## UNITED STATES DEPARTMENT OF THE INTERIOR BUREAU OF LAND MANAGEMENT

SUNDRY NOTICES	AND	REPORTS	ON	WELLS
----------------	-----	---------	----	-------

2. Name of Operator			· · · · · · · · · · · · · · · · · · ·	<b>-</b>  #211		
OXY USA WTP Limited Partnership		192463		0 ADV 37/ 11 37		
3a. Address 3b. Phone No. (include area code)				9. API Well No. 30-025-11046		
P.O. Box 50250, Midland, TX 79710-	0250	432-685-5717		10. Field and Pool, or Exploratory Area

**OXY USA WTP LP** Myers Langlie Mattix Unit #211 API No. 30-025-11046

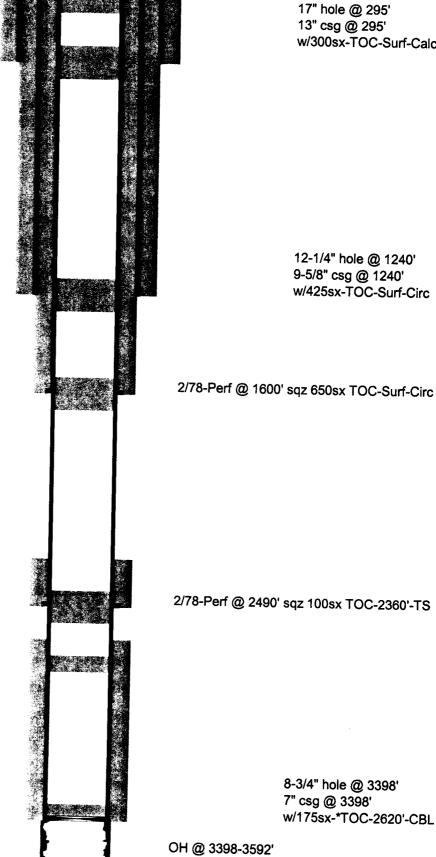
roval is granted to plug this well with the following modifications to the losed procedure:
2. All	plugs at casing shoes and the tops and base of the salt must be tagged.
***All plugs	below the surface plug must be at least 100' and 25 sacks of cement.
can be re	Engineering ached at 505-706-2779 for any variances that might be necessary.
F Wright 12/1	13/06
